**Plan Commission Staff Report  
Department of Planning and Building  
Town of McCordsville**

**Project:** Villages at Brookside, Sections 14-15

**Request:** Petitioner is seeking approval of the Development Plan and Secondary Plat for Sections 14-15

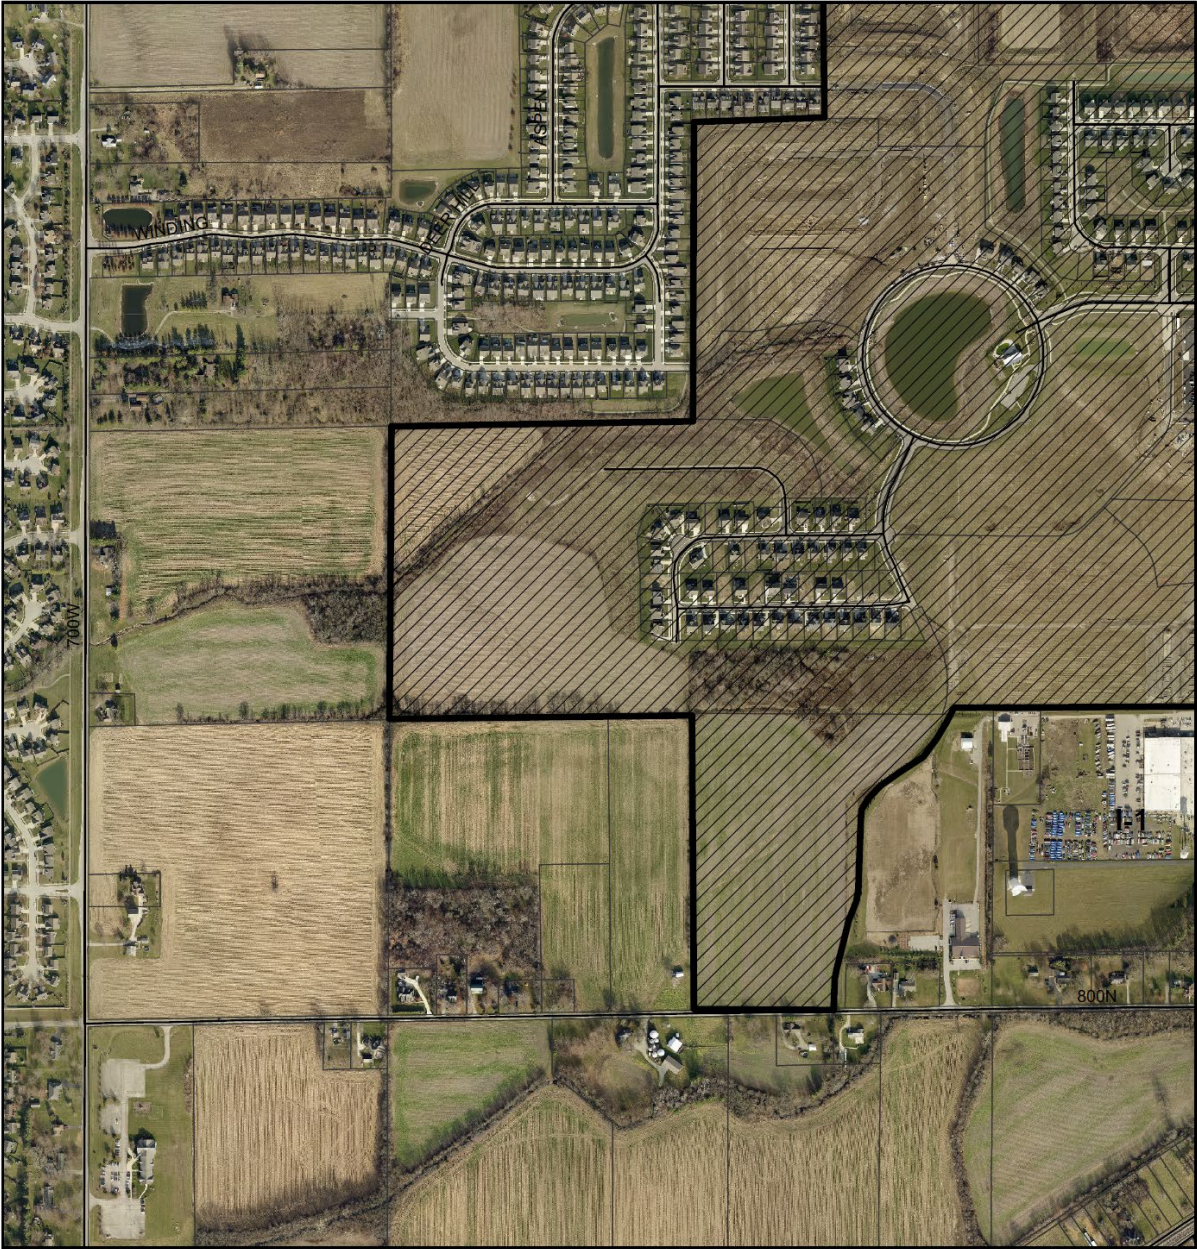
During staff's initial plan review, conducted at the March Technical Advisory Committee (TAC) meeting, we concluded that Sections 14-15, as filed with 53 lots brought the total lot count for Areas B & D of the Villages at Brookside PUD to 334 lots. The max lot count for those two areas (per the PUD) is 332. Our TAC letter denoted this issue and the petitioner removed 2 lots and sought your approval with a 51-lot filing. Since, the approval last month the petitioner has provided additional documentation outlining their belief that the additional 2 lots are still under the maximum lot count included in the PUD.

The Villages at Brookside PUD includes a number of “Areas”. Each Area has its own lot count. For the purposes of this petition, Areas A, B, & D are the applicable Areas. Areas B & D are calculated together as they are the only Areas of the PUD that have not been amended over the years and they both feature traditional, single-family homes. Area A originally allowed 111 lots for a single-family, detached, active adult product. In 2015 an Amendment to the PUD was approved for the Traditions at Brookside project. That Amendment allowed the senior living development and an additional 28 lots for single-family, detached, active adult homes. Obviously, the senior project was constructed, and the petitioner moved forward with their Patio Series Homes on the remainder of Area A. However, staff was unaware that two lots that feature the Maple Street product were actually included within Area A’s legal description, thus making them a part of Area A’s lot count and not Area B’s. With these two lots counting against Area A instead of Area B, it allows for Sections 14-15 to feature 53-lot instead of 51-lots. Ultimately, when accounting for the maximum lot count of all three Areas, the project is exactly at the maximum lot count.

Staff has enclosed an exhibit which shows the boundary line of the legal description for Area A. The two lots highlighted are the 2 Maple Street Series Homes that staff initially counted as part of Area B. Upon receiving this documentation, staff has reversed its previous position and finds that Sections 14-15, as presented with 53 lots, are in keeping with the maximum lot count for Areas A, B & D of the Villages at Brookside PUD.
